TECH TIPS TO HELP YOU AT THE SHOP BENCH

## 09G/TF60SN Valve Body Gasket Update

PI# 79940 (ORIGINAL DESIGN)

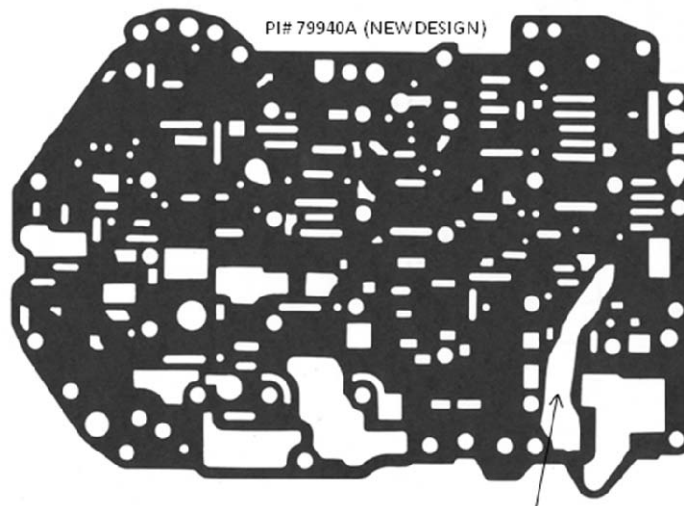
Precision International is pleased to announce the update to the 09G/TF60SN valve body gasket. The original design had a tendency to blow out causing the paper material to clog the valve body. New design, PI #79940A, has paper material removed from gasket to combat the issue of valve body clogging. As of date code 12146 you will notice new gasket in our K79900HX overhaul kit family. See illustrations below that highlight our updated design.

Area of gasket that blows out and causes paper material to clog valvebody.

PI# 79940A (NEW DESIGN)

Paper material that is removed from gasket to combat the issue of valvebody clogging.
